**RESOLUTION HOLDING HEARING ON APPEAL BY MENARD, INC.  
OF DENIAL OF TYPE 2 DESIGN ALTERNATIVE FOR SITE PLAN FOR PROPERTY  
LOCATED AT 6000 SOUTHEAST 14<sup>TH</sup> STREET**

**RE: Request for City Council Review of Plan and Zoning Committee Decision**

Communication from the City Plan and Zoning Commission advising that at their October 7, 2021 meeting, the following action was taken regarding a request from Menard, Incorporated (owner), represented by Nicholas Brenner (officer), for review and approval of a Public Hearing Site Plan “Menards Expansion”, for property located in the vicinity of 6000 Southeast 14<sup>th</sup> Street, for a Type 2 Design Alternatives in accordance with Chapter 135 Sections 135-9.2.4.B and 135-9.3.1.B, to allow expansion of an outbuilding within an “CX-V” Mixed Use District while retaining an off-street parking lot that does not meet the minimum interior parking lot landscape standards, per City Code Section 135-7.9.2.A.

## **STAFF REPORT TO THE PLANNING COMMISSION**

1 SITE PLAN  
 SCALE: 1" = 60'-0"

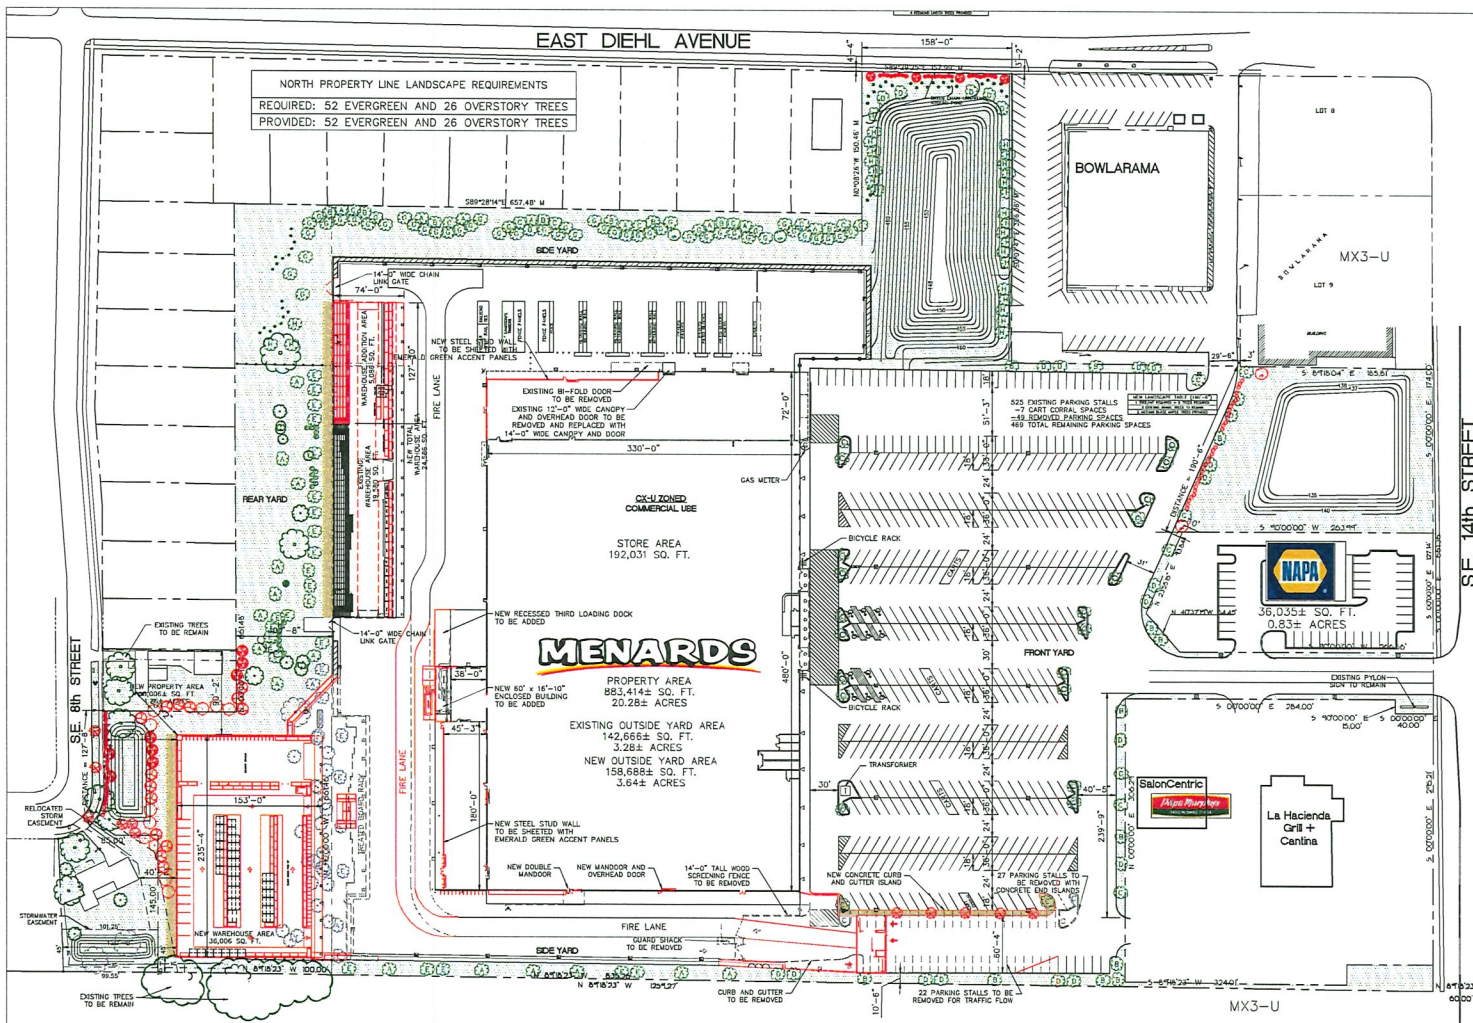
**2. Design Alternatives:** The developer has requested review and approval of Design Alternate to allow interior parking lot landscaping which does not meet the interior parking lot landscape standard requiring a minimum landscape island within every 9th parking space and 30 % shading requirement of the interior lot per section 135-7.9.2.A.

Due to parking lot modifications as part of the Menards expansion, the applicant has indicated that they are proposing 10 new islands at the terminal ends of the parking rows bringing the total number of Islands from 23 islands to 33 islands. An approximately 1200 square-foot buffer with 7 trees is proposed as a divider between the parking lot and storage yard access drive and accounts for a majority of the new islands that are indicated in the narrative. The following table summary shows a deficiency of 53 planter islands but accepting the large island as an alternate design in lieu of 7 islands would reduce this total to 46 interior islands deficient. The table also shows a deficiency of approximately 4,770 sq. ft. of interior planter island area assuming 1200 sq. ft. for the large alternate design island and 25 sq. ft. for each existing island that is currently encapsulated by concrete. They typical island is 5-foot by 17-foot with a minimum area of 85 square feet.

A majority of the current planter islands do not meet the minimum dimensions of 5-foot by 17-foot landscape as required by code therefore many of the existing islands would need to be modified to meet this minimum requirement for the optimal growth potential of the overstory trees. The applicant has indicated that these modifications will take weeks to perform in the middle of their busiest retail season and impact their customers directly. They have indicated that parking lots within 250 feet of this property are very similar to what they are proposing and adding the interior islands is both impracticable and undesirable for their business.

Access drives on new and existing sites are expected to provide overstory trees every 30 lineal feet on each side of the drive. As Menards owns the approximately 300-foot-long access drive which fronts two other developments, it would be typical to provide the over story trees 30 foot on center with the renovations proposed.

Staff does not concur with the applicant's desire to forego the required interior lot landscape island improvements. The quantity of parking spaces that would be compromised would not present an impact on the minimum parking requirement. Additionally, the installation of interior islands could be done in phases so that the entirety of the parking lot is not impacted during the site improvements This would help alleviate the impacts on the parking lot during the hours the store is open. Staff recommends an alternate design which would allow the spacing of planters to be placed in every 11 parking stalls rather than every 9 parking stalls required by code.

It is important to provide the mitigating effect of the tree shading on the expansive parking lot and having the planters would help to further reduce the amount of impervious surface and help to achieve the 30% canopy coverage. While staff appreciates the applicant's proposal to reduce the existing paving condition, the provision of the interior islands are critical to meeting the intent of the Ordinance. The interior parking lot landscape standard has been appealed to, reviewed, and upheld by the Planning and Zoning Commission with conditions at a number of sites within the last year. Staff would also like to emphasize the need for over story tree plantings on

each side of the access drive from the street to the store located within the same parcel.

Staff does not support waiver of the required interior landscaping. This is based on the finding that other than the additional cost, the provision of the required islands would not adversely impact the parking demand and present congestion, but would rather further the intent of the Ordinance to minimize impervious surface and provide necessary shading canopy over time to reduce the heat island effect. Staff is supportive of an alternate design that would allow a planter island every 11<sup>th</sup> parking stall as opposed to every 9<sup>th</sup> parking stall.

1. Provide the required interior lot landscape and overstory tree generally at every 11<sup>th</sup> parking stall to the satisfaction of the Planning and Urban Design Administrator.

2. Provide one tree every 30 lineal feet on each side of the access drive to the satisfaction of the Planning and Urban Design Administrator.
3. Each existing planter shall be amended to a have minimum planter area of 5-foot by 17-foot or 85 square feet of soil area.
4. Compliance with all administrative comments. (10-2021-7.18)
